**Stannah Safety Bulletin – TB 97 Updated advice
re: Pawl device & replacement VMD Valves**

TECHNICAL BULLETIN

Product : Stannah MRLi - Hydraulic Passenger Lift

Subject : **Updated advice** - Pawl device and replacement down pilot valves

Figure 1 - Location of VMD

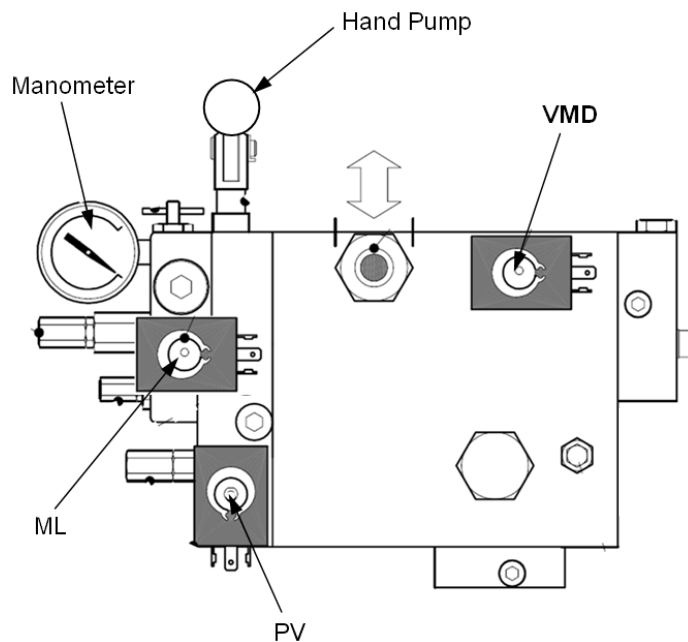
Identification of VMD:

Figure 2 - Distinguishing features of old and new VMD valves

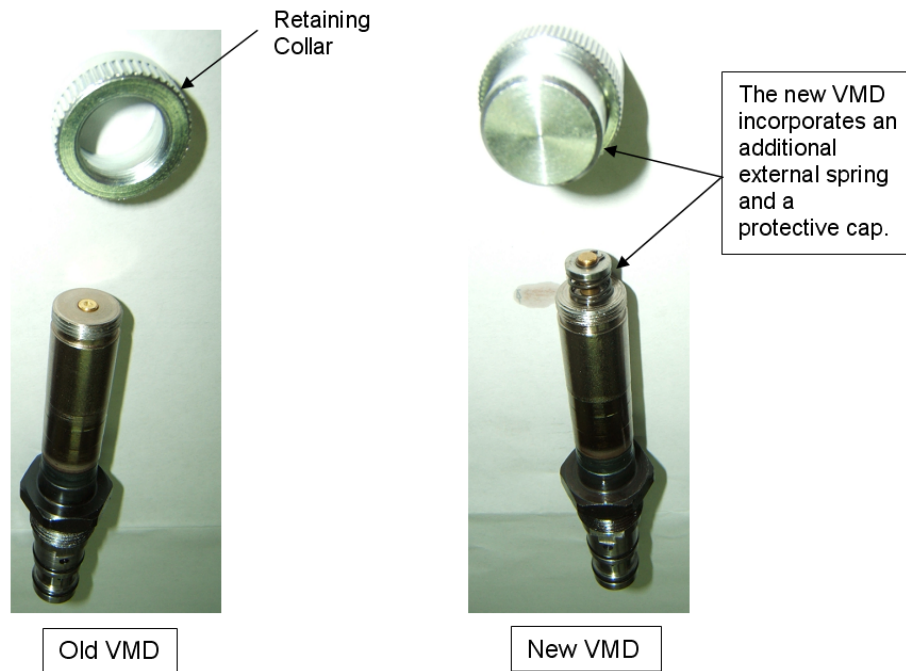
By way of this bulletin we want to emphasise the importance of fitting the new design VMD, such that the valve upgrade must take place. New VMD valves are supplied free of charge with all necessary fitting instructions. Replacement should be undertaken before or at the next scheduled service interval. **This operation takes approximately 5 to 10 minutes.**

- All MRLi models with the old version VMD are to have the newer version VMD fitted before or at the next scheduled service interval.
- Action points of bulletin TB82 (fitting of pawl devices etc) are to be progressed for cases where additional safety, over and above requirements of EN81-2, is desired.
